PRODUCT: TRIPLINES

APPLICATION: ALL STANDARD VALVE BAMBI BUCKET MODELS

PURPOSE: PRODUCT INFORMATION REGARDING NEW TRIPLINE DESIGN

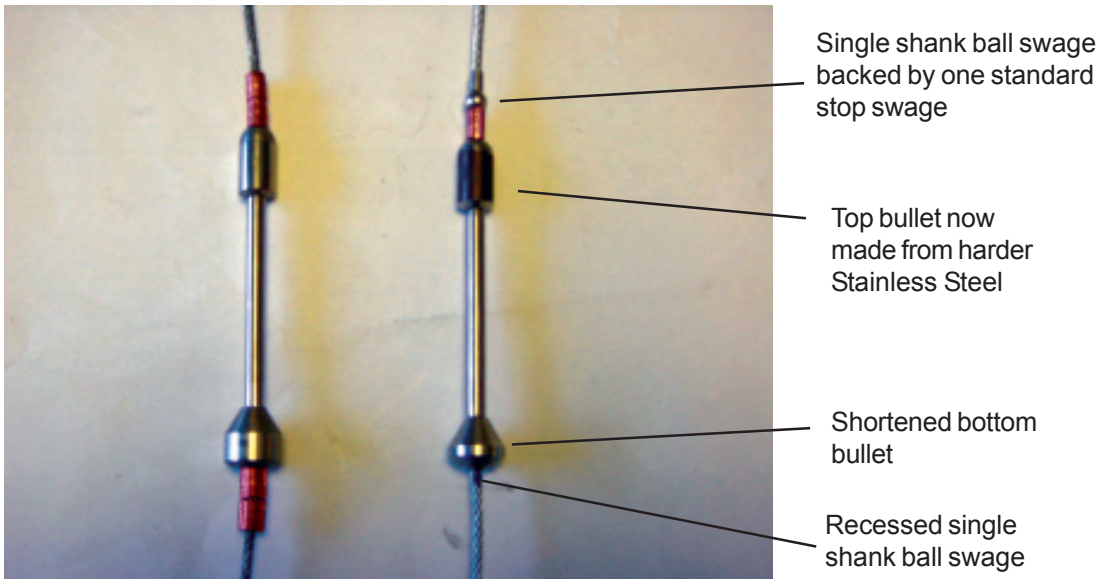
OVERVIEW: As of January 2004, SEI industries will supply Triplines that conform to a new improved design specification. The new Triplines are fully retrofittable replacements for the old design, and do not require any additional parts for installation. The improvements are focused on improving the durability of the catch bullet stack and cable immediately below the lower swage.

New tripline installed in Control Head. Lug Plates installed. **Note:** Control Heads built after January 2004 will not require Lug Plates.
